RE: DRAINAGE SUBMITTAL RECEIVED AUGUST 29, 1985 (L9-D3)

REF: REVISED GRADING PLAN FOR SUNSET WEST UNIT I (PHASE 2) (L9/D3)
RECEIVED MAY 31, 1985

RE: COMMENTS ON DRAINAGE REPORT
SUNSET WEST SUBDIVISION UNIT ONE

ENGINEER'S REPORT ON
STORM DRAINAGE
FOR SUNSET WEST
SUBDIVISION UNIT 1

**PROPOSED TEMPORARY DIVERSION
(TYP. at SAN YGNACIO RD.)**

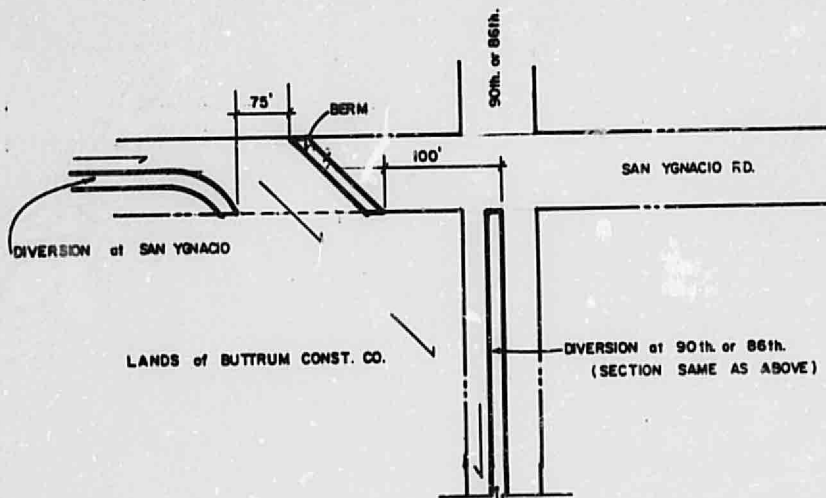
Item 1 - It is proposed to effect the turn from San Ygnacio to 90th Street in a channel with a 150 foot radius with dike protection each side of the channel, and the accumulated flow will be turned off 90th Street into the existing arroyo approximately 100 feet north of Sage Road with a similar channel-dike system. The channel-dike at the intersection of San Ygnacio and 90th Street will be largely contained in the street intersection, and the lot area in the northeast corner of the "Future Development" will not be developed until the permanent drainage facility is constructed upstream (see Pg 2-Hydrology & Hydraulics-Drainage Report for Description of The Permanent Facility).

TYPICAL SECTION A-A
SAGE ROAD
Near 98th Street
East Side

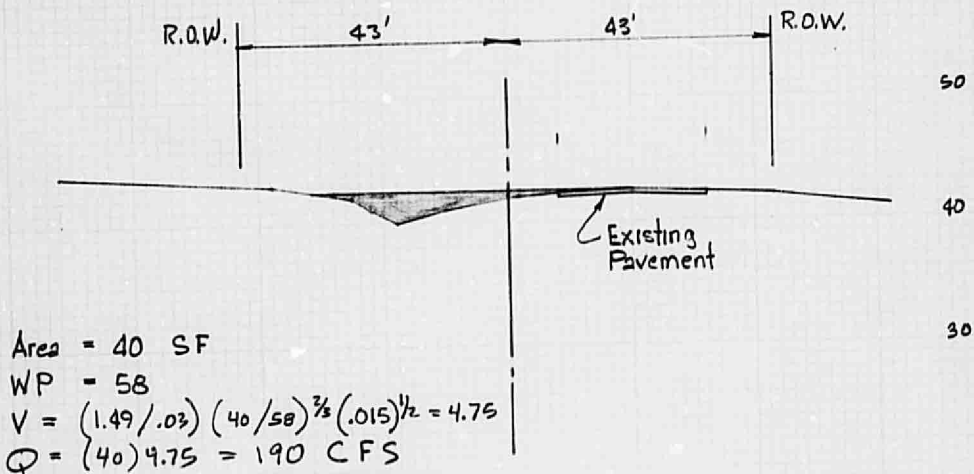
2. Exhibit "A" shows clearly that the drainage flows in a Southeasterly direction. Section B-B (See exhibit B) shows a maximum capacity of 551 C.F.S. for Sage Road west of the 98th Street-Sage Road intersection. (60 C.F.S. is entering the intersection from 98th Street) per the report. Section C-C indicates no confinement of these flows on the south side of Sage from 100' to 200' within the intersection. Because there is no confinement, the water will sheet flow to the south and east of the ditch and dike section on the west side of Snow Vista Blvd. Sections A-A and D-D show that the existing capacity of Sage Road east of 98th Street to be 190 C.F.S. if that much gets there. This figure is somewhat larger than the 150 C.F.S. shown in the drainage report M9-D1. These cross sections were taken from the contour map for Westview Townhomes. Any flows greater than 190 C.F.S. will flow in a southeasterly direction, not east in Sage Road.
